Public Comment on May 7, 2010 on the Continuing Overall Failure to Install the Required Network of Monitoring Wells at the Three RCRA Regulated Units (MDAs G, H and L) at Technical Area 54 at the Los Alamos National Laboratory

Robert H. Gilkeson, Registered Geologist

Figure 4. Map of TA-54 area showing updated water-table contours following installation of seven new monitoring wells between December 2008 and June 2009. Note the change to the prior water-table map (Figure 3) is the apparent north, northeastern component of flow in the vicinity of MDA H.

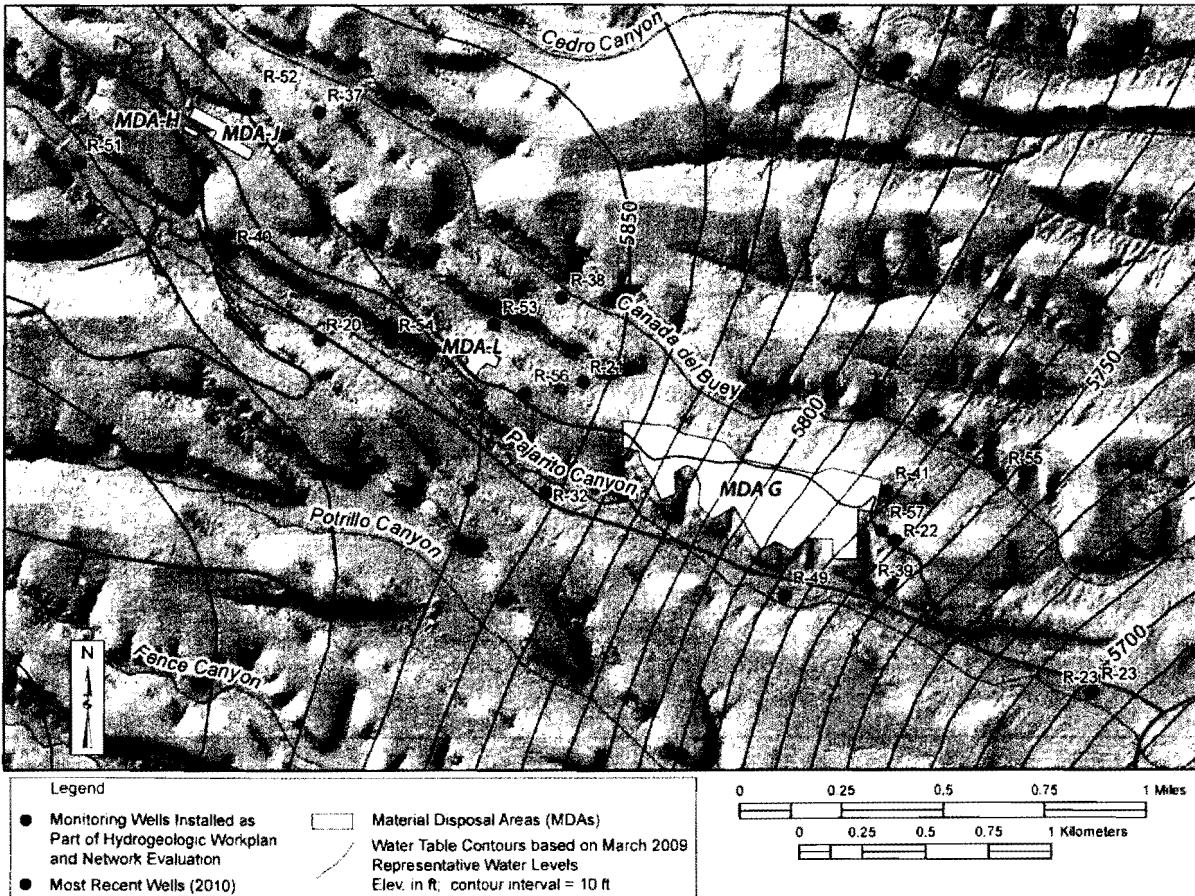
The network of monitoring wells installed or proposed for the regional aquifer at Technical Area 54 (TA-54) at Los Alamos National Laboratory (LANL) are shown in the attached Figure 4 from the Katzman Testimony Exhibit 4 at the public hearing for the LANL proposed Part B Permit. Except for well R-23i, all of the monitoring wells displayed on Figure 4 are installed in the regional aquifer. Well R-23i is a well with two screens that are installed in perched zones of saturation.

Schlumberger<sup>R</sup> Geophysics for LANL Well R-22.  
Source: LANL Report LA-UR-04-677 (September 2004). AR 13899

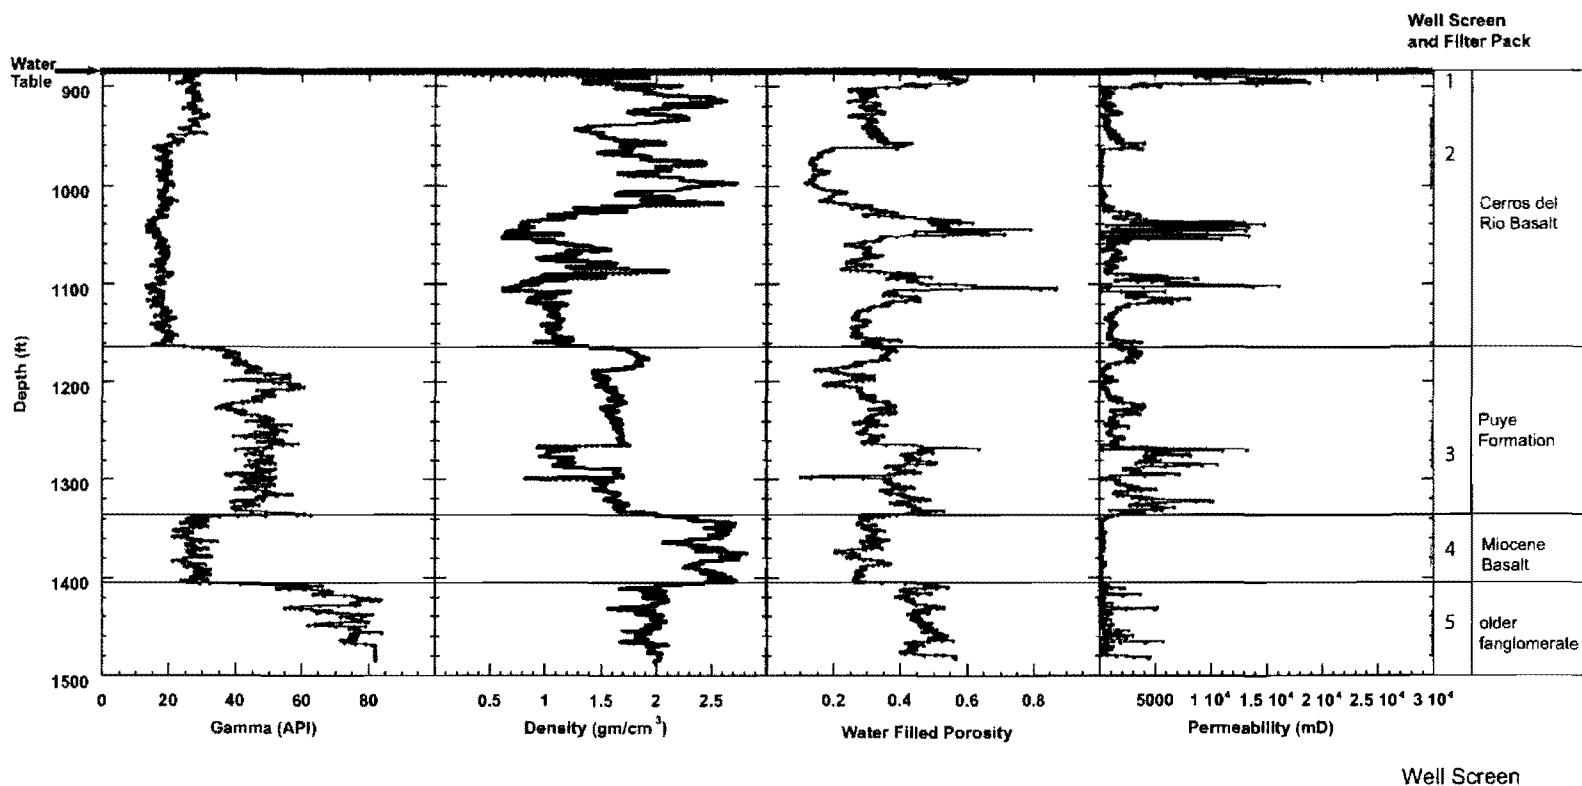
The attached figure from LANL Report LA-UR-04-677 (September 2004) is a summary of the Schlumberger geophysics for well R-22. The figure shows two aquifer zones with high permeability that are not monitored by well R-22. The two zones are located below screen #2 and above screen #3 in the approximate depth intervals of approximately 1030 – 1065 feet below ground surface (ft bgs) and 1085 – 1135 ft bgs. In addition, the lithologic log in the LANL Well R-22 Completion Report (LA-13893-MS, February 2002) describes an aquifer zone with high permeability in the depth interval of 1188 – 1237 ft bgs. The three aquifer zones described in this paragraph must be investigated for the presence of contaminated groundwater by the installation of monitoring wells.

Figure 4. Map of TA-54 area showing updated water-table contours following installation of seven new monitoring wells between December 2008 and June 2009. Note the change to the prior water-table map (Figure 3) is the apparent north, northeastern component of flow in the vicinity of MDA H.

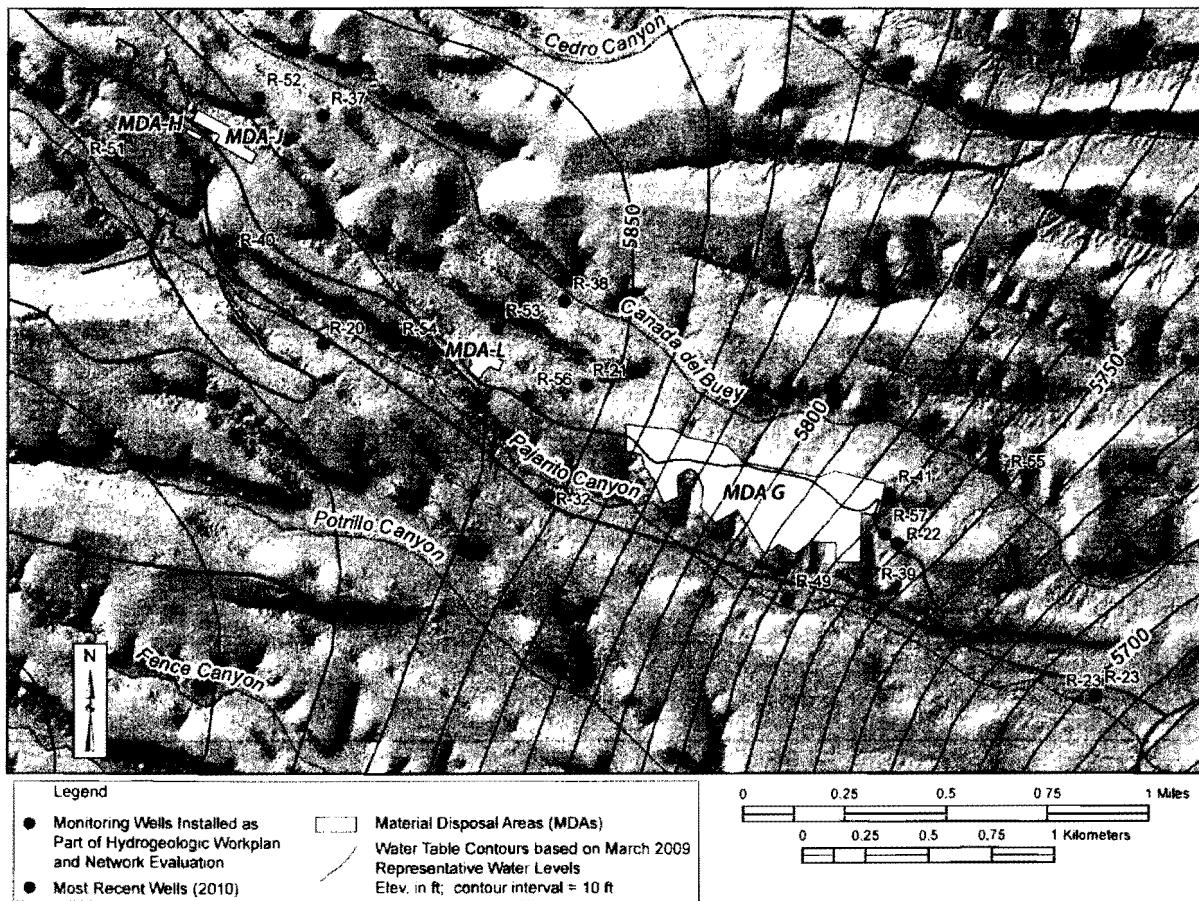
The network of monitoring wells installed or proposed for the regional aquifer at Technical Area 54 (TA-54) at Los Alamos National Laboratory (LANL) are shown in the attached Figure 4 from the Katzman Testimony Exhibit 4 at the public hearing for the LANL proposed Part B Permit. Except for well R-23i, all of the monitoring wells displayed on Figure 4 are installed in the regional aquifer. Well R-23i is a well with two screens that are installed in perched zones of saturation.

Schlumberger<sup>R</sup> Geophysics for LANL Well R-22.  
Source: LANL Report LA-UR-04-677 (September 2004). AR 13899

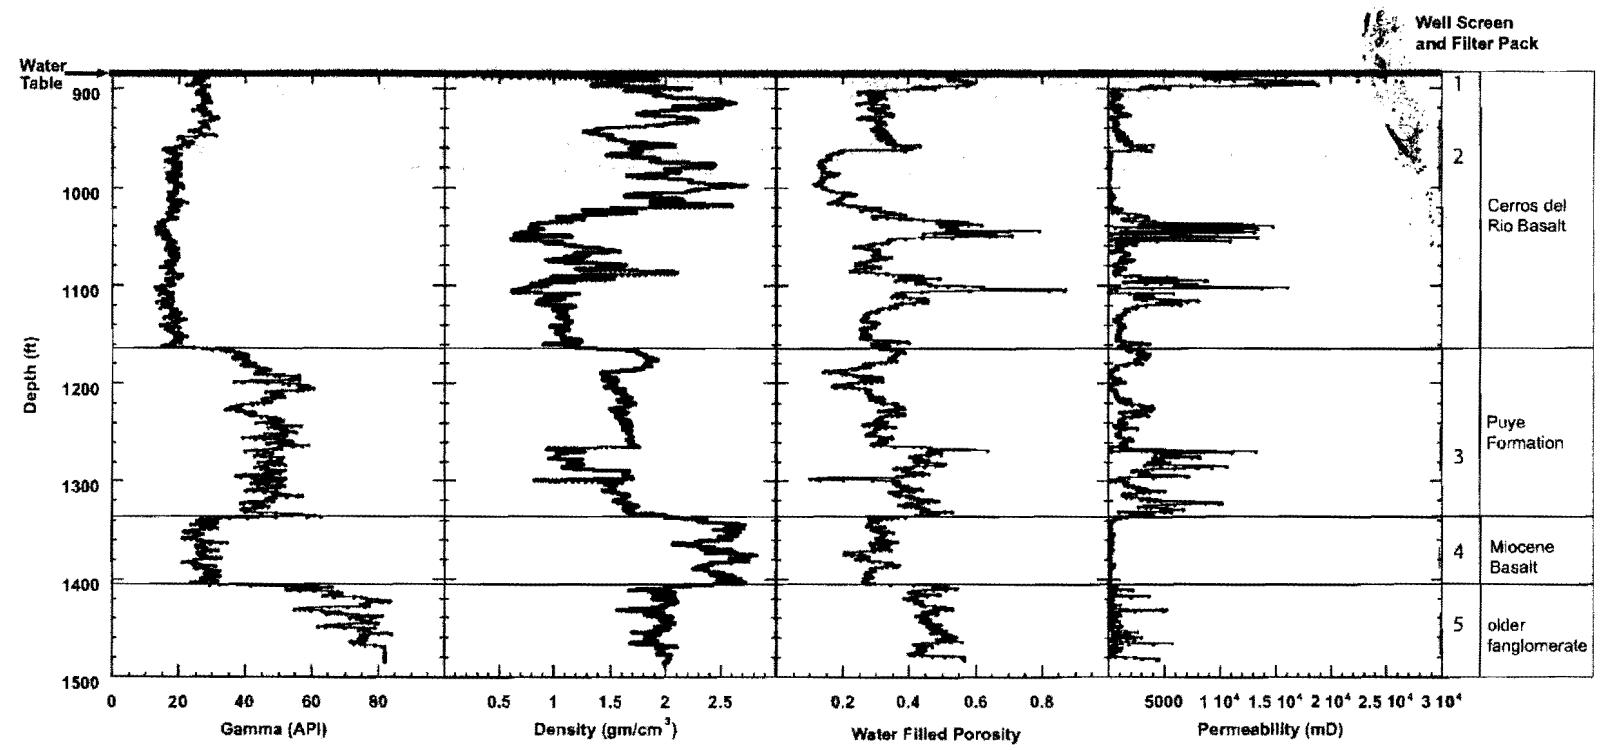
The attached figure from LANL Report LA-UR-04-677 (September 2004) is a summary of the Schlumberger geophysics for well R-22. The figure shows two aquifer zones with high permeability that are not monitored by well R-22. The two zones are located below screen #2 and above screen #3 in the approximate depth intervals of approximately 1030 – 1065 feet below ground surface (ft bgs) and 1085 – 1135 ft bgs. In addition, the lithologic log in the LANL Well R-22 Completion Report (LA-13893-MS, February 2002) describes an aquifer zone with high permeability in the depth interval of 1188 – 1237 ft bgs. The three aquifer zones described in this paragraph must be investigated for the presence of contaminated groundwater by the installation of monitoring wells.
